**ADDENDUM no. 2 to the
FINAL ENVIRONMENTAL IMPACT REPORT/ENVIRONMENTAL ASSESSMENT for
the
U.S. HIGHWAY 50/EL DORADO HILLS BOULEVARD-LATROBE ROAD
INTERCHANGE PROJECT**

AUGUST 2008

Project Title: U.S. Highway 50/El Dorado Hills Boulevard-Latrobe Road Interchange
EIR/EIS ADDENDUM no.2

FIGURE B

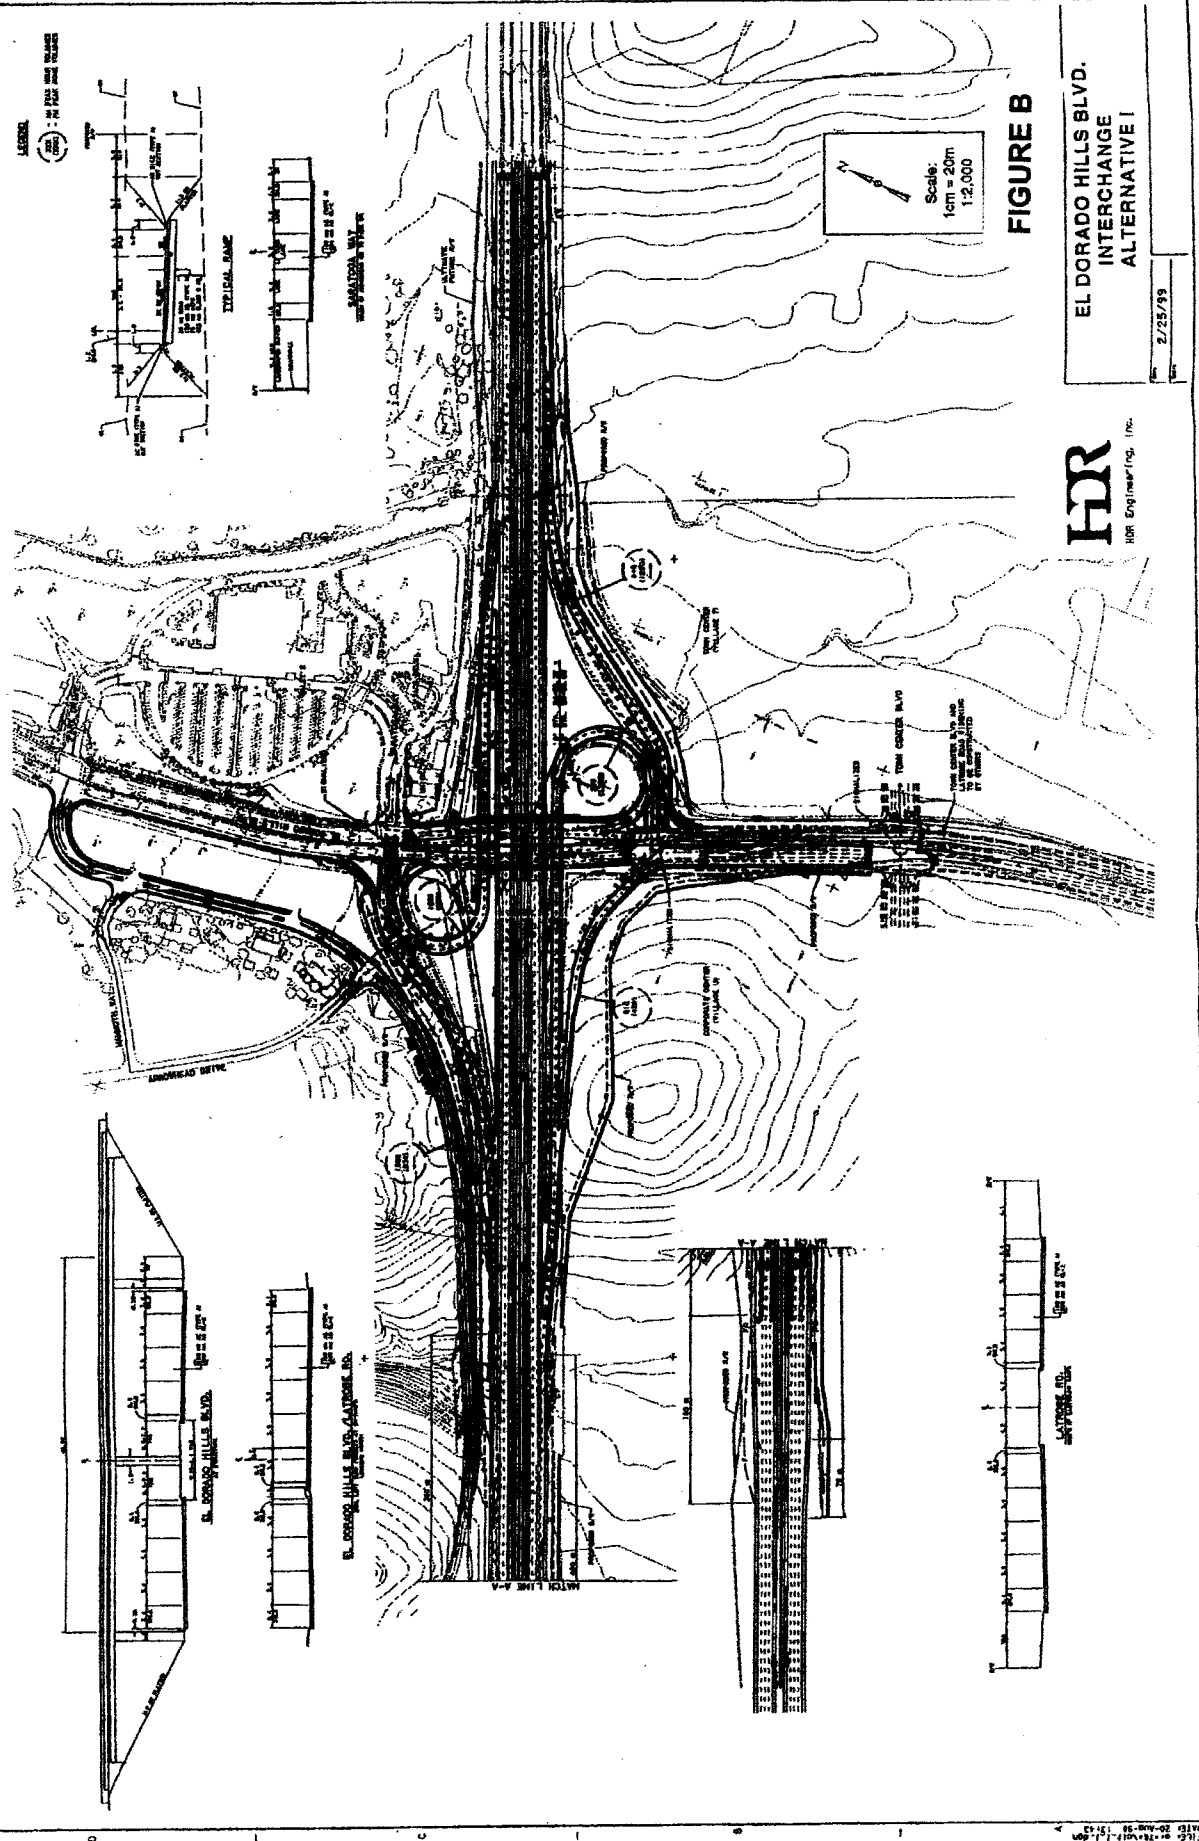
In the proposed project the alignment of the EB off-ramp will be modified from the ultimate configuration in the EIR/EA, shown in Figure B, to an interim condition as shown in Figure J in order to align the ramp with the replacement bridge. This interim phase does not include lengthening and widening (to 2 lanes) the eastbound to southbound off-ramp due to funding limitations. The ramp will remain a single lane instead of 2 lanes and the gore point will occur between the existing and ultimate gore points for the interim condition. This results in a shorter, narrower ramp for the interim condition. The ramp will remain a dedicated ramp for northbound El Dorado Hills Blvd traffic for the interim condition. The ultimate EB ramp alignment will be constructed in Phase 2B per the EIR/EA, as shown in Figure B.

FIGURE C

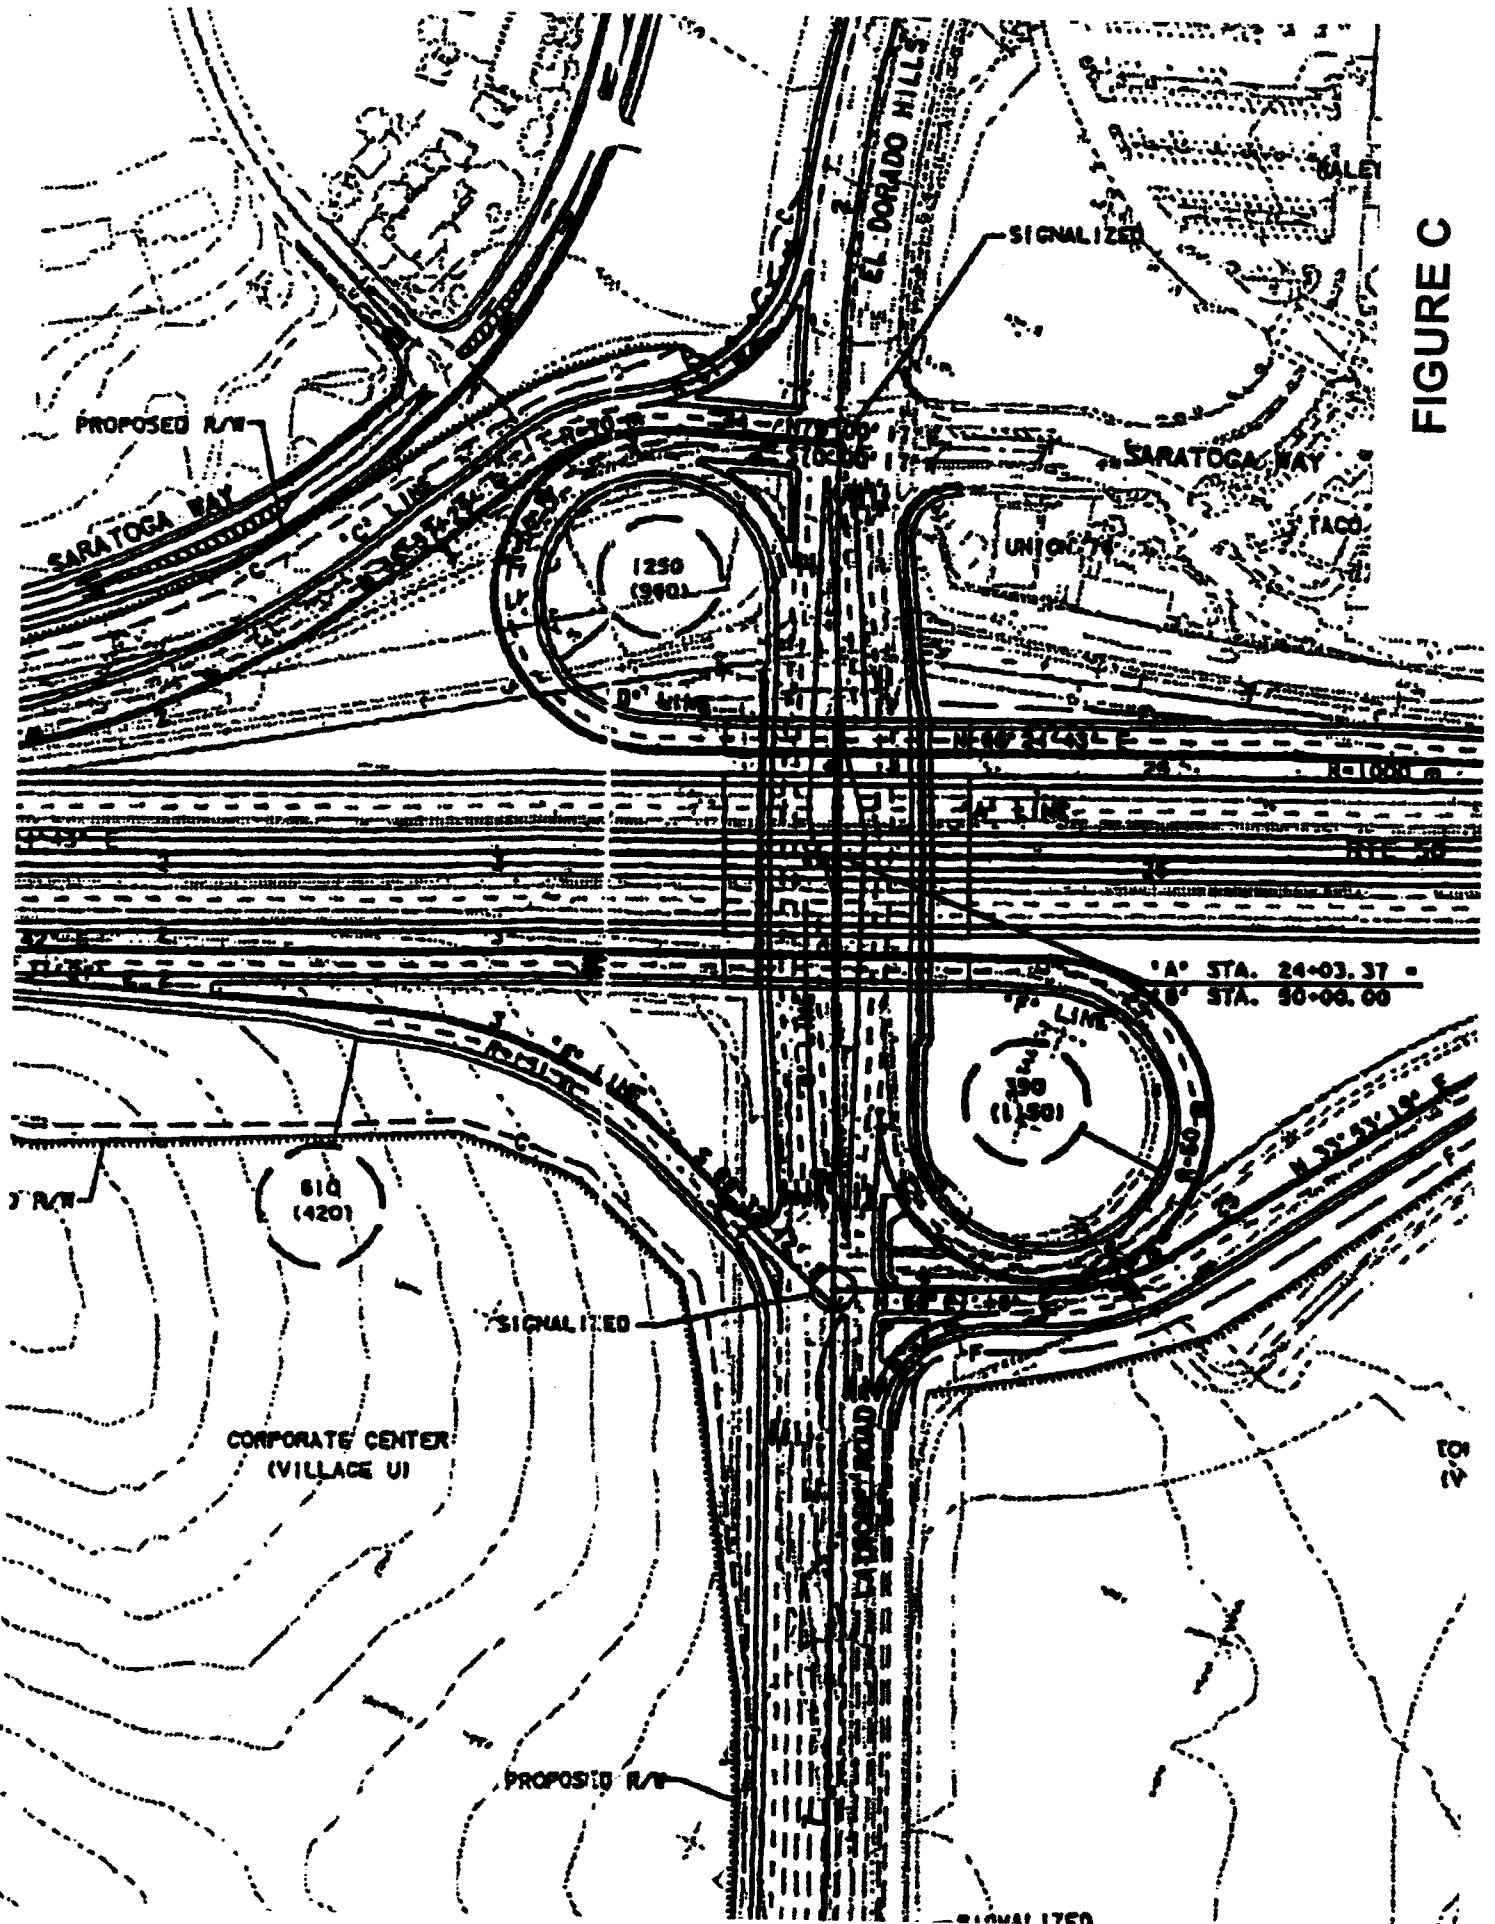
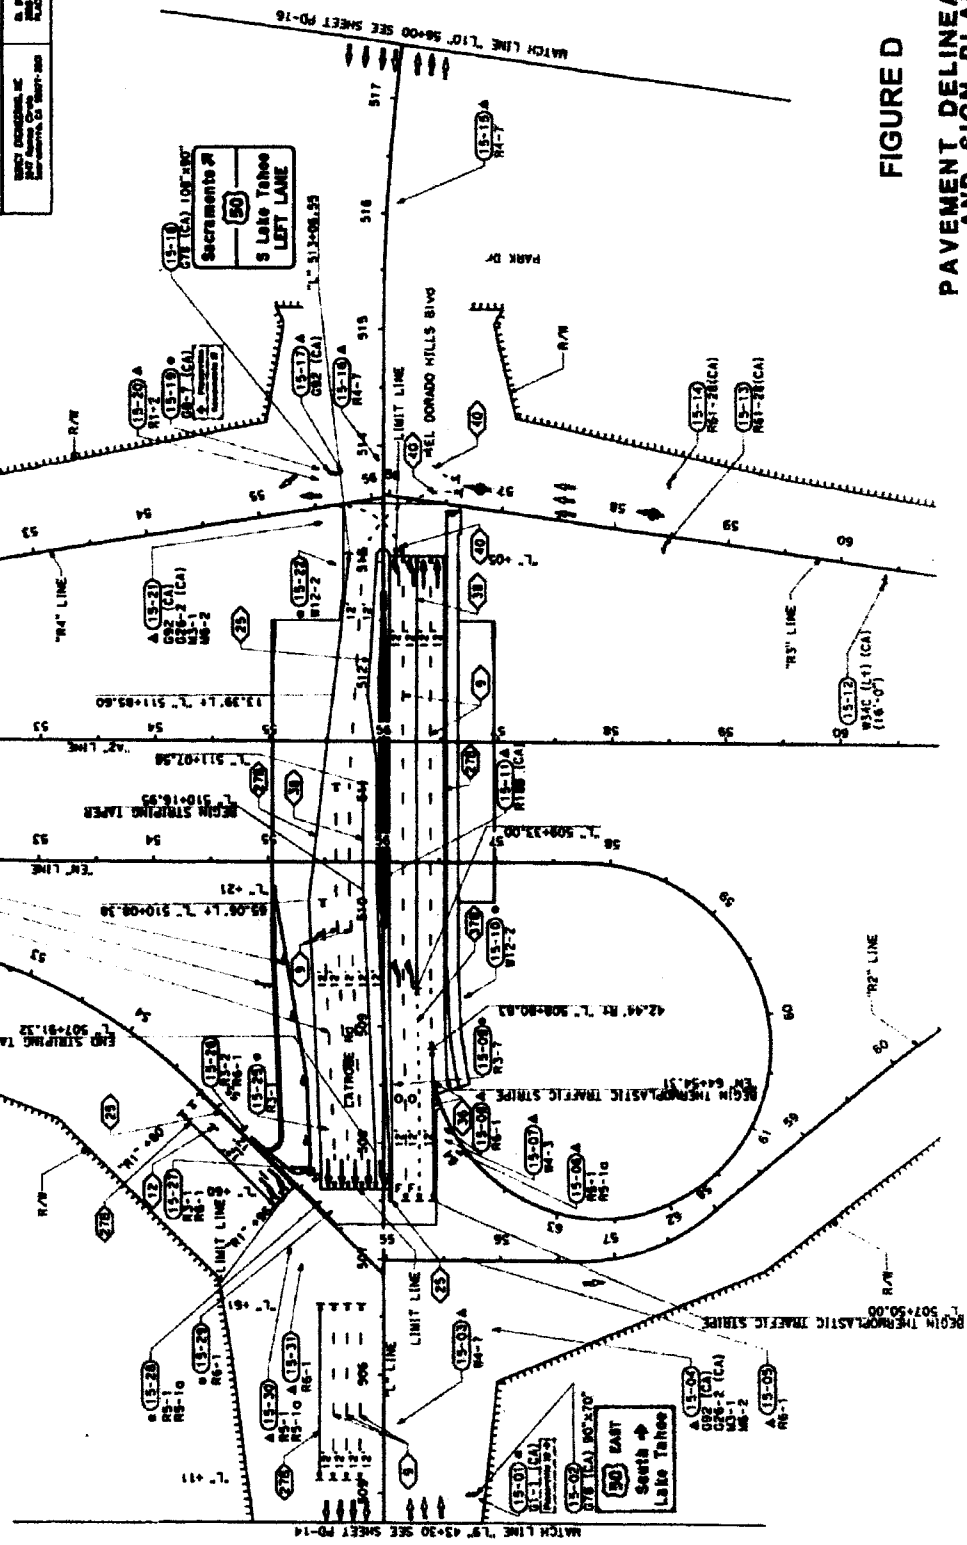
The approved project included the construction of three through lanes and two dedicated left-turn lanes on the northbound and southbound sections of El Dorado Hills Boulevard/Latrobe Rd beneath the bridges and approaching the adjacent intersections with the Hwy 50 ramps as shown in Figure C, which is an enlargement of Figure B. Phase 2A proposes to construct, as an interim condition, the lanes shown in Figure D.

A traffic study by Dowling Associates (November 6, 2007), Figure E, indicates that the length of the turn lanes depicted in the EIR/EA must be increased to operate at level-of-service D or better at the intersections. To prevent traffic from spilling back into the through lanes and blocking through traffic, the needed minimum length of the two northbound lanes is 875 feet long and, ultimately, the two southbound lanes need 550 feet. The current proposed construction phase will extend the two existing northbound and a single southbound turn lanes to provide more storage capacity for turning traffic as shown on Figure D. The second southbound turn lane will be striped in phase 2B after the ramp is widened to receive the second turn lane.

The roadway width on El dorado hills Blvd/Latrobe Rd between the interchange ramps will be increased from approximately 130 feet to a varying width of approximately 130 feet to 190 feet in phase 2A to accommodate the lengthened turned lanes and to accommodate the remaining through and turning traffic lanes constructed in phase 2B. In addition, the lane striping at the southbound approach to the El Dorado Hills Boulevard/Latrobe Rd intersection with the Hwy 50 eastbound ramps will be modified to 4 through lanes and one dedicated left-turn lane (see Figure D) in this interim phase 2A. These 4 through lanes will provide operational improvements at the ramp intersections by providing more through lanes thus reducing the congestion caused by cars spilling back from the single left turn lane and blocking through traffic. The current project would provide paved surface for 5 lanes and permit the ultimate phase configuration of 3 through and 2 left turn lanes after modifications to the eastbound on-ramp in phase 2B to receive 2 lanes.

FIGURE G

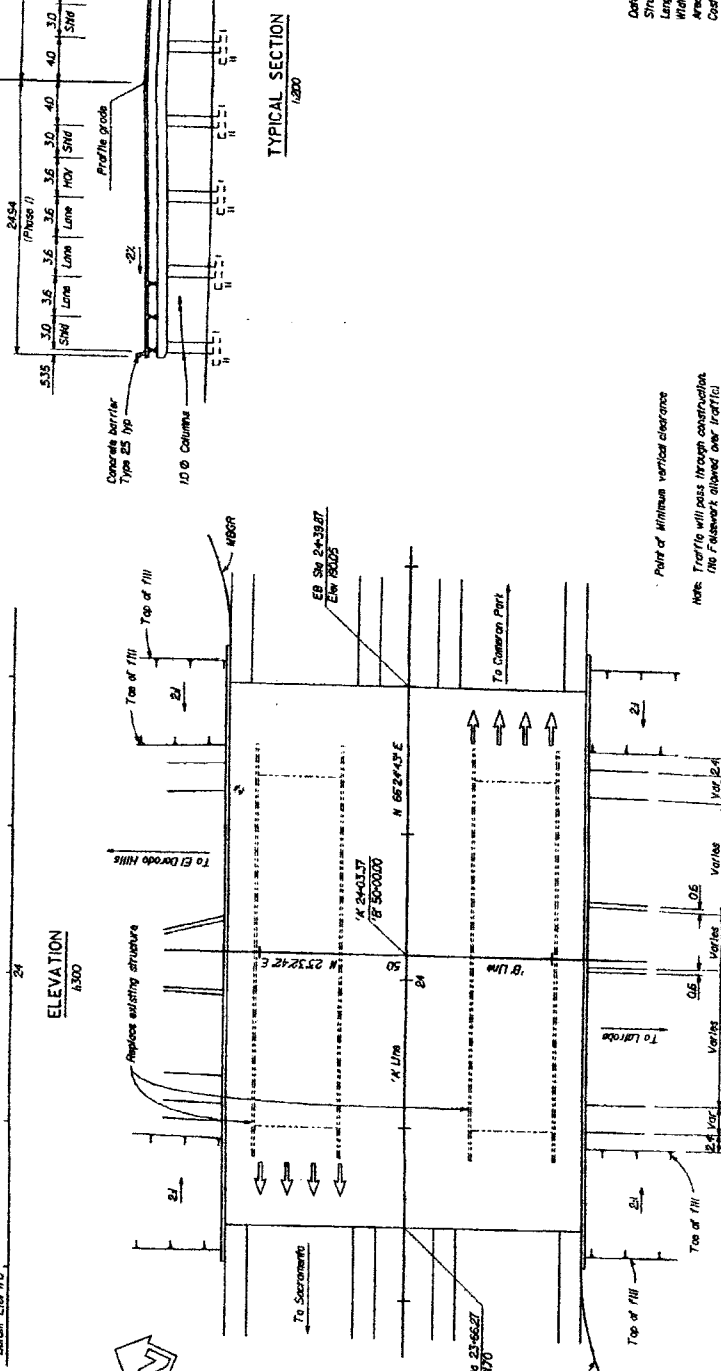
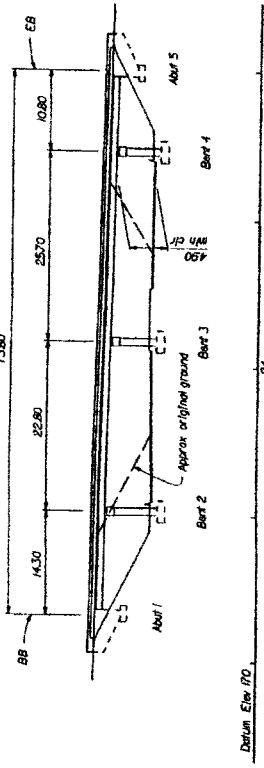
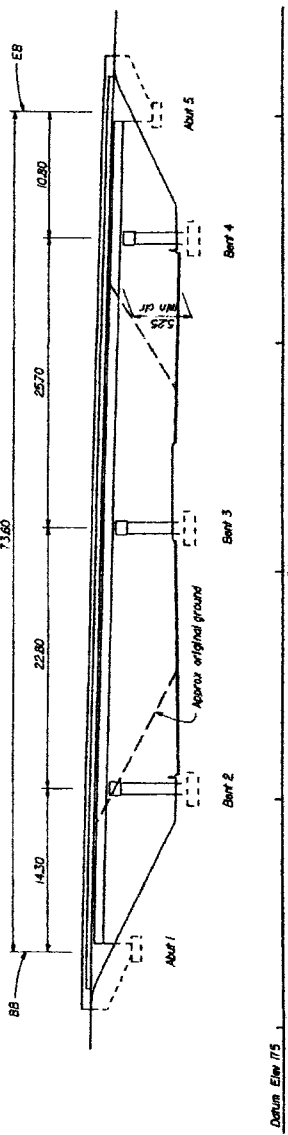
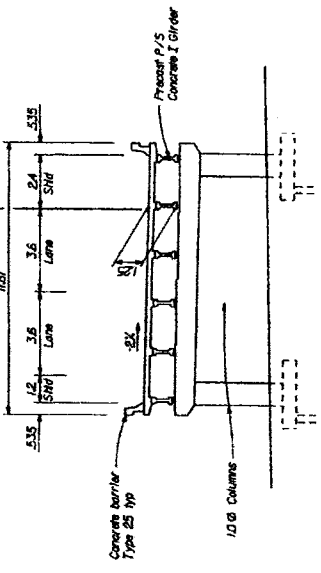
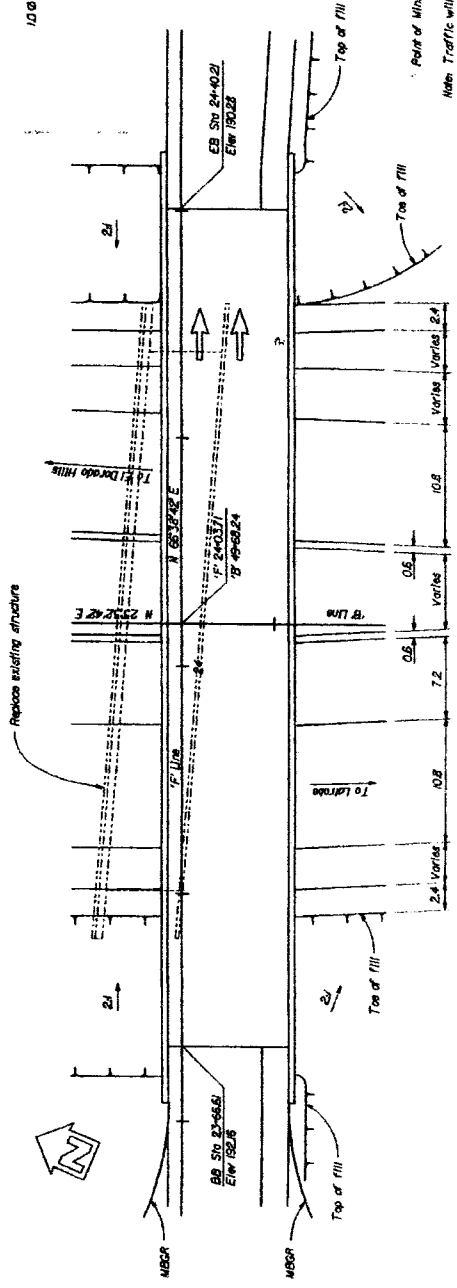
The approved project included the replacement of bridges for the US 50 mainline traffic and the eastbound off-ramp traffic. Detailed discussion and detailed drawings of the bridges were not included in the EIR/EA but general depictions of the bridges were included within the exhibits. However, the County is aware of the bridge type and dimensions of the bridges depicted in the EIR from the preliminary design work done at that time. The original mainline bridge is depicted in Figure F and the EB off-ramp bridge is depicted in figure G.

The original type of bridge structure (4 span, cast in place concrete box girders with open end abutment) could not be economically built due to the requirement to maintain a minimum vertical falsework clearance for traffic under the bridge during construction. The proposed replacement bridges are 2 span precast concrete box girders with closed end abutments. The proposed mainline bridge is depicted in Figure H and the EB off-ramp bridge is depicted in Figure I. The bridge length is shorter partially due to hauling limitation for the precast girders. It is also shorter and narrower than the bridge proposed in the EIR/EA because the larger size is not needed and it reduces costs.

The original design dimensions of the mainline bridge in the June 2000 Project Study Report/Project Report (PSR/PR) were 241.5 feet long and 163.67 feet wide. The current proposal would replace the existing mainline bridge with a structure that is 200 feet long and 141 feet wide. The proposed EB off-ramp replacement bridge is shorter for the same reasons but the width (39 feet) remains the same as the bridge in the PSR/PR. The proposed EB off-ramp bridge is 200 feet long vs. 241.5 feet long in the PSR/PR. All replacement bridges are within the same footprint area.
